Pearsall A #3

30-025-36546

SUNDRY NOTICES AND REPORTS ON WELLS

Mack Energy Corporation

MACK ENERGY CORPORATION
Pearsall A #3
Sec 33 T17S R32E 2310FSL 380FEL

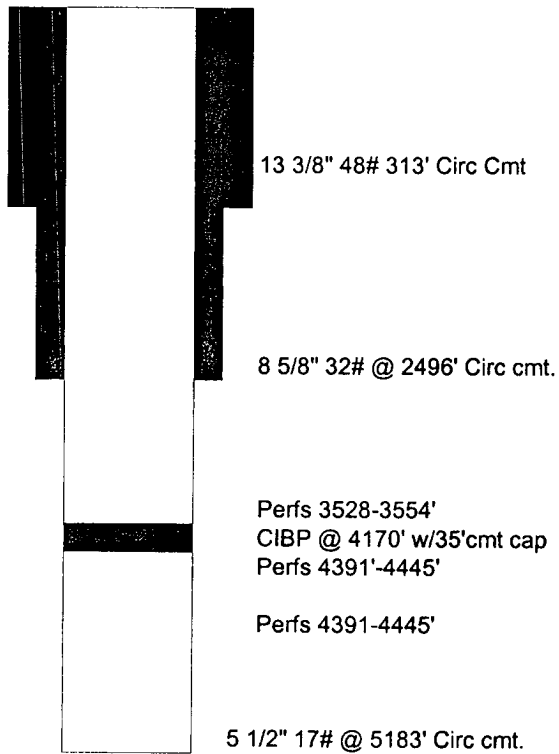
1. Notify BLM 24 hours prior to starting plugging operations.
2. Set CIBP @ 3428' above perfs @ 3528' w/35' cement cap. *Set at 3475'*
3. Circ hole with mud get.
4. Set 100' cement plug 2546' - 2446' 50' above and below 8 5/8" shoe. *TAG*
5. Set 100' cement plug 363' - 263' 50' above and below 13 3/8" shoe. *TAG*
6. 60' circ cement to surface.
7. Install dry hole marker.
